<b>Title - Sujet</b> Const.Quai de la Reine section93&94	
<b>Solicitation No. - N° de l'invitation</b> EE517-191340/A	<b>Amendment No. - N° modif.</b> 012
<b>Client Reference No. - N° de référence du client</b> R.083401.001	<b>Date</b> 2019-01-22
<b>GETS Reference No. - N° de référence de SEAG</b> PW-\$QCM-018-17559	
<b>File No. - N° de dossier</b> QCM-8-41101 (018)	<b>CCC No./N° CCC - FMS No./N° VME</b>
<b>Solicitation Closes - L'invitation prend fin</b> <b>at - à 02:00 PM</b> <b>on - le 2019-01-25</b>	<b>Time Zone</b> <b>Fuseau horaire</b> Heure Normale du l'Est HNE
<b>F.O.B. - F.A.B.</b> <b>Plant-Usine:</b> <input type="checkbox"/> <b>Destination:</b> <input checked="" type="checkbox"/> <b>Other-Autre:</b> <input type="checkbox"/>	
<b>Address Enquiries to: - Adresser toutes questions à:</b> Piras, Gabriel	<b>Buyer Id - Id de l'acheteur</b> qcm018
<b>Telephone No. - N° de téléphone</b> (418) 649-2870 ( )	<b>FAX No. - N° de FAX</b> (418) 648-2209

## Reconstruction of Wharfs 93 and 94, Quai de la Reine Quebec (Quebec) Amendment 012

1. Questions and answers 58 to 61

##### DREDGING

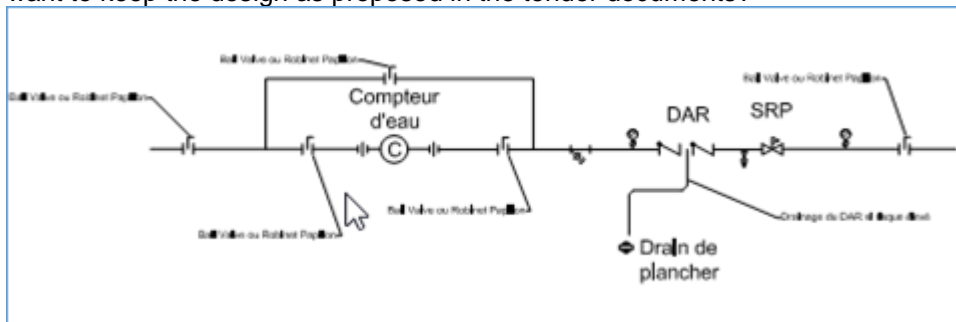
According to specifications 02 41 16 you say in item 1.4.3 'do the cleaning to remove these obstacles and ensure their demolition if required and available prior to the piling of the combined wall to facilitate the installation of piles and sheet piles in the required tolerances' However in the #8 amendment you tell us in the section 01 32 16.07 item 1.7 ".1 dredging cannot be done before June 30, 2021 and will not be made before the installation of piles and sheet piles of the combined wall and their stabilization using rock anchors. More in the 01 11 00 payment item.5 Connections to the existing wharves we must remove armouring stone page G06. The question: are we allowed to do the dredging before June 30, 2021?

**Answer :** Cleaning of the corridor to pile is not considered as dredging. The date of June 30rd, 2021 does not apply to the cleaning of the corridor to pile.
